PRODUCT BULLETIN
2008-03

PRODUCT:
Single Row Right Angle Board to Board Connectors

PART NUMBER SERIES:
RLSA, RLSS

TYPE:
Material Change

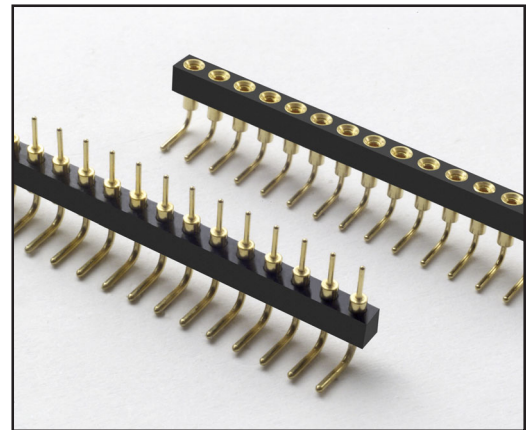
The insulator material for Single Row Right Angle Board to Board Connectors has been changed to FR-4 (Fiberglass Epoxy Board) from molded LCP (Liquid Crystal Polymer).

The part number series has changed as follows:

Description	Previous Series	New Series
Single Row Female Right Angle Connector	RLSA	FLSA
Single Row Male Right Angle Connector	RLSS	FLSS

FR-4 - Fiberglass Epoxy Board. UL rated 94V-O. Color: Black. Thermal Index to 140°C.
